# TDP, mask and VECP

Piers Dawe

IEEE P802.3bm, Jan 2014, Indian Wells

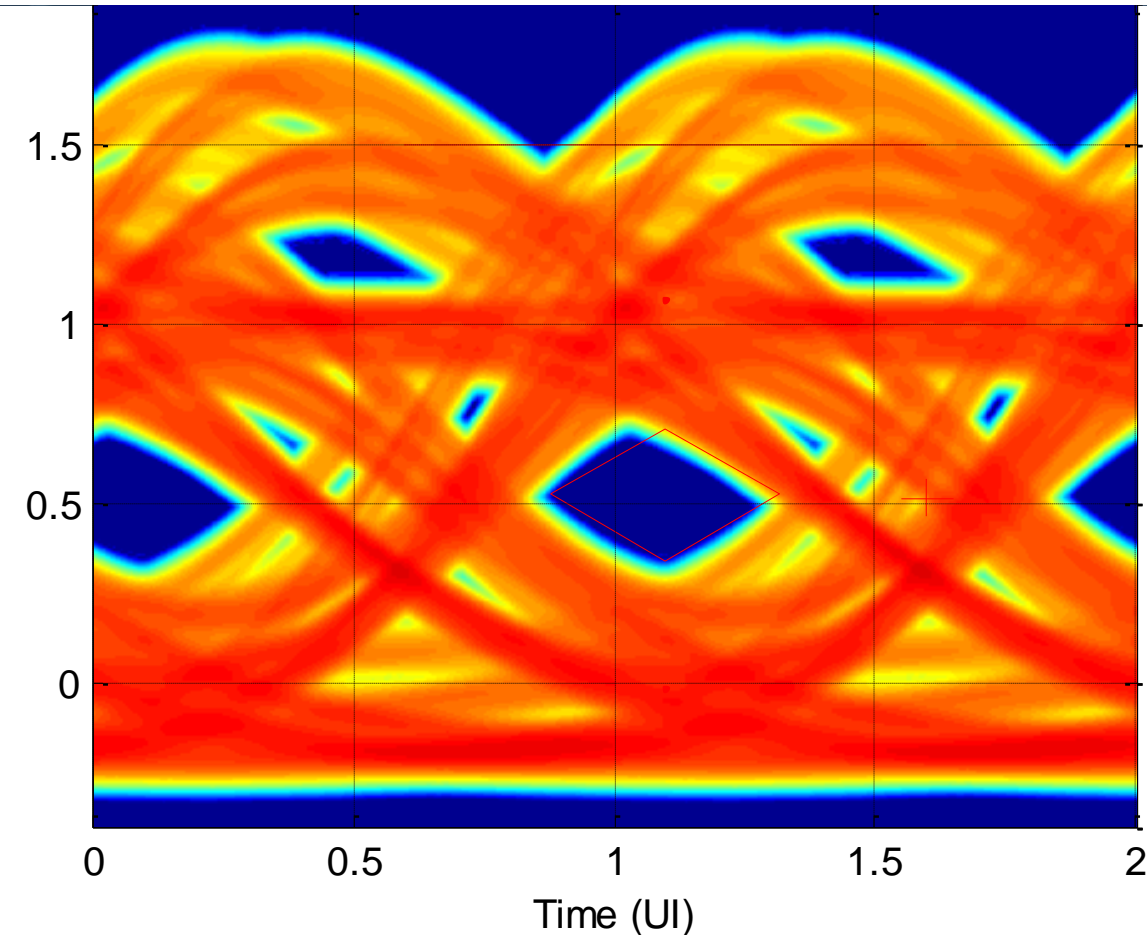
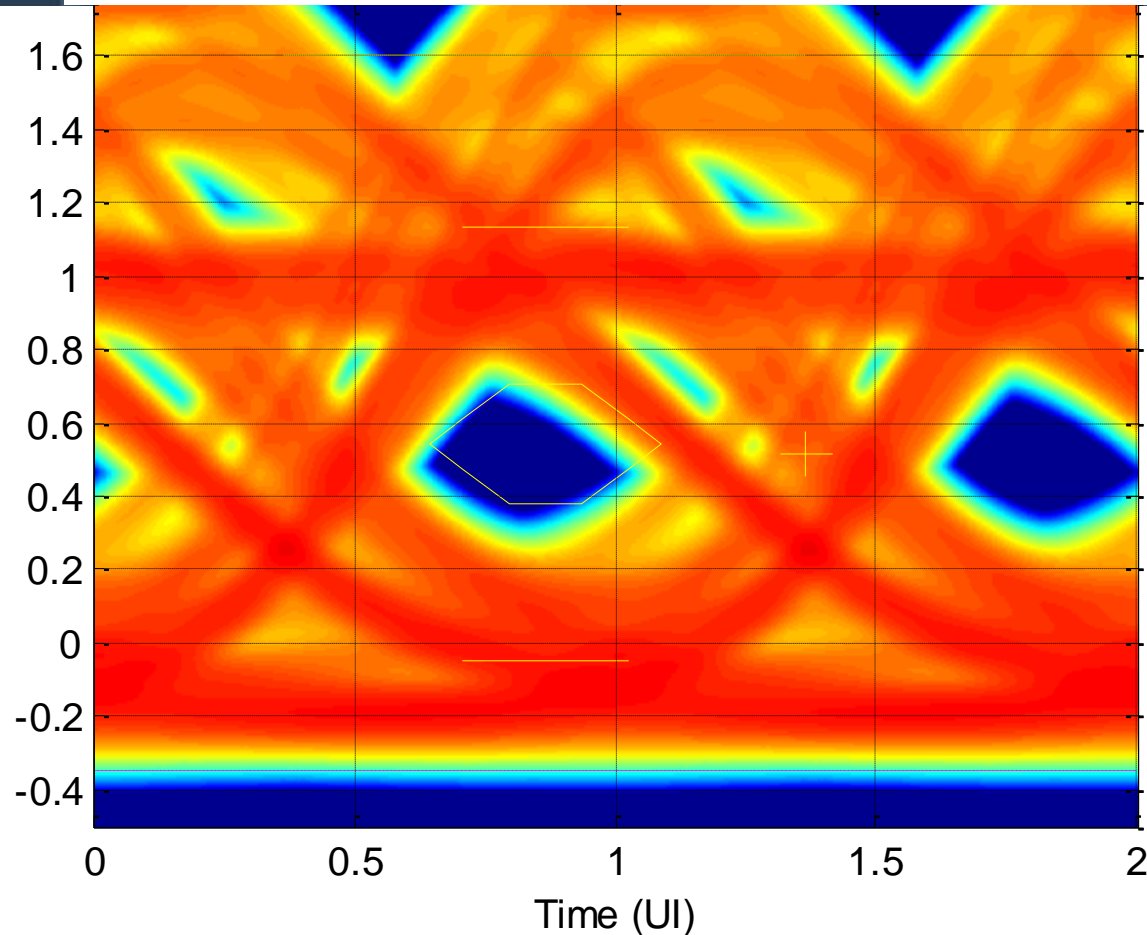
- This is a simulated laser eye with a TDP of 2.86 dB (2.07 dB without VECP error)
- The eye is barely passing the inner mask, but fails the outer mask (yellow mask, magenta shows extent of signal)
- A signal with a TDP of 5 dB could fail the mask by a large margin (see next slide)
- Mask needs to be made easier: both inner mask smaller (Y1, Y2) and outer mask larger (Y3)

- This is a simulated laser eye with a TDP of 4.95 dB (4.16 dB without VECP error)
- The eye fails both inner mask and outer mask (yellow mask, magenta shows extent of signal)
  - Also it's difficult to get an accurate measure of OMA with PRBS9
- Mask needs to be made easier: both inner mask smaller (Y1, Y2) and outer mask larger (Y3)

PMD type	Inner eye Y1	Inner eye Y2	Outer eye Y3
1000BASE-SX	0.2	0.2	0.3
10GBASE-SR (A)	0.25	0.28	0.4
10GBASE-SR (B)	0.235	0.265	0.4
40GBASE-SR4	0.27	0.35	0.4
100GBASE-SR4	0.36	0.44	0.4
  - This time we need to increase Y3 to keep up with changes in Y1, Y2. Increase Y3 to 0.55

## Simulated eye with TDP approaching 5 dB

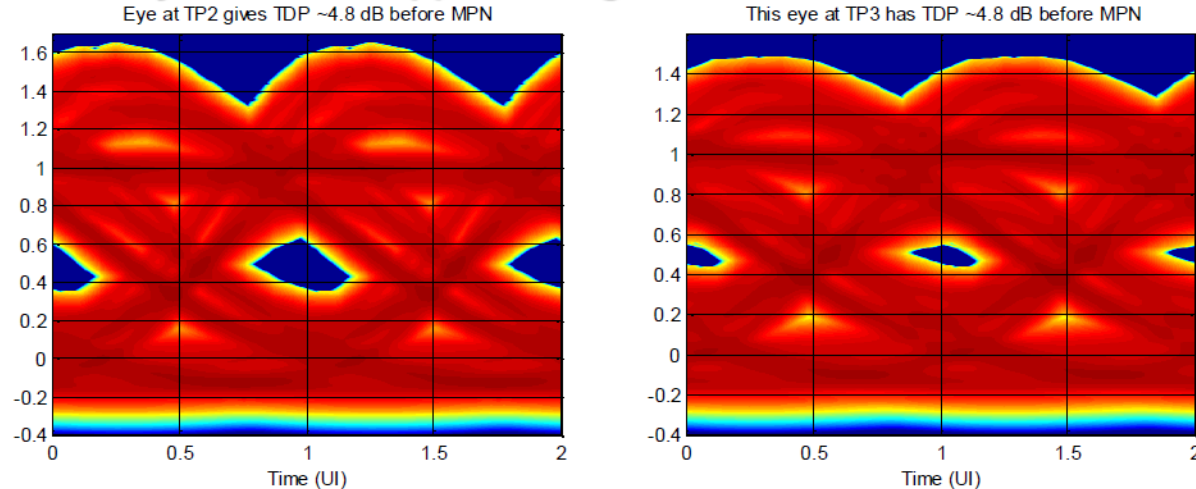
- TDP like Clause 52: +/-0.05 UI, but:
  - BER = 5e-5
  - 100 m of OM4 modelled as a Gaussian filter, like spreadsheet model
  - Standard fourth-order Bessel-Thomson
- Includes ISI from chromatic dispersion but not MPN
- Is this on the cliff edge?

## TDP vs. signalling rate

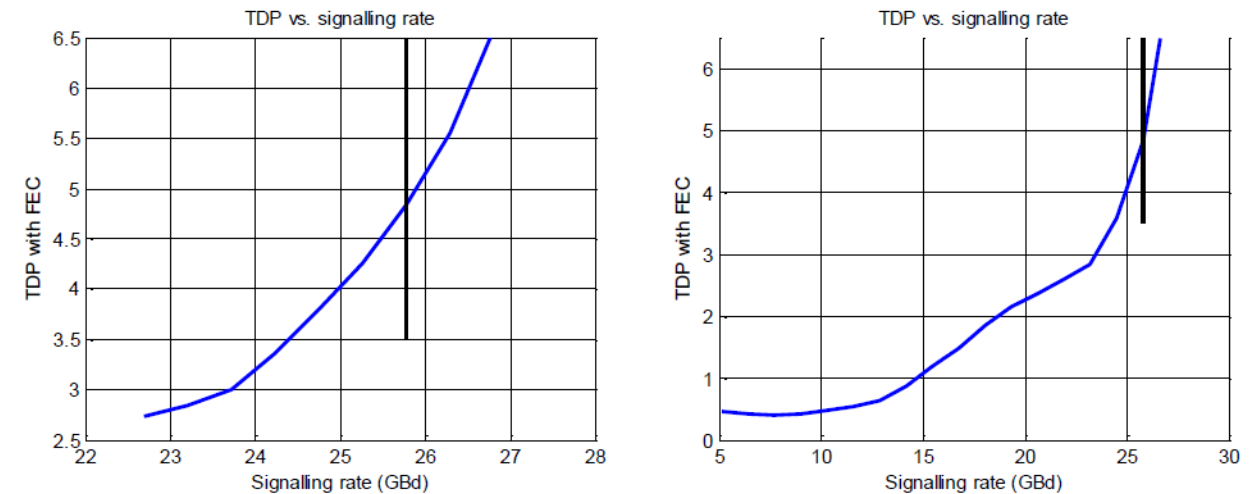
- IC bandwidths scaled with signalling rate, laser not scaled
- 2% rate change increases TDP by 0.7 dB – yes, cliff edge

- The colour scale here is not the same as previous slides
- Also we need to find an additional 0.2 dB in the budget for modal noise penalty (see daw\_e\_04\_0114\_optx.pdf)
- This eye is on the "cliff edge": about to collapse. **Widening the decision timing offsets has helped**

- It seems that 5 dB TDP is too high anyway
